PHY Naming Proposal for Discussion at P802.3dm Ad Hoc Meeting of March 17, 2026 – [Revision A](#)

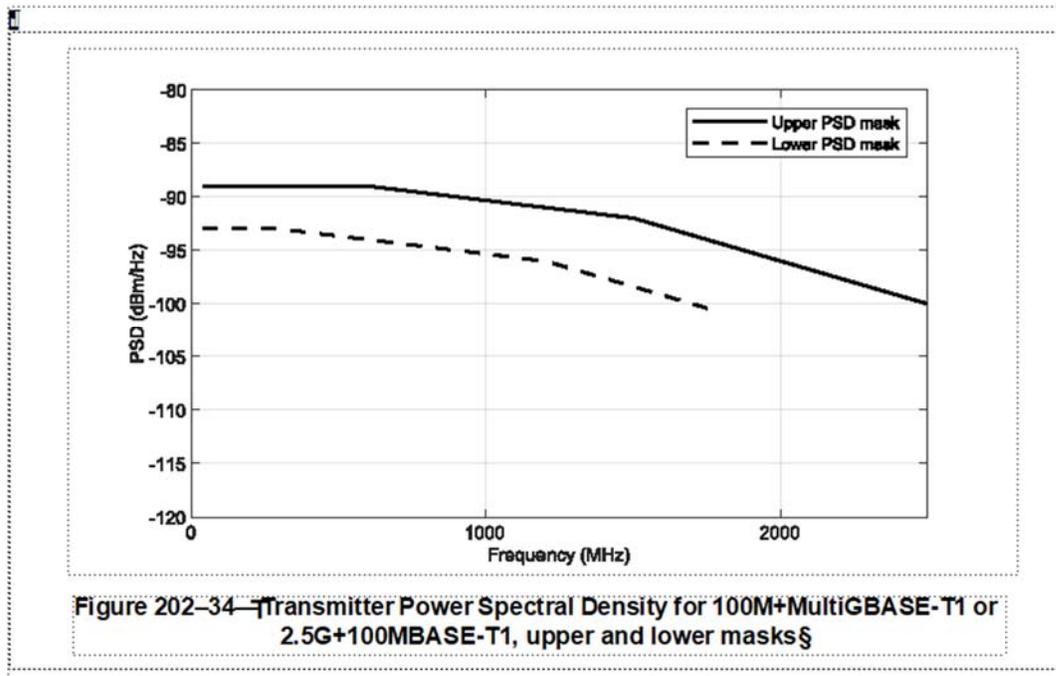
Labels for Transmitter PSD need to be adjusted to align with Table 202-15

Table 202-15 will look like this:
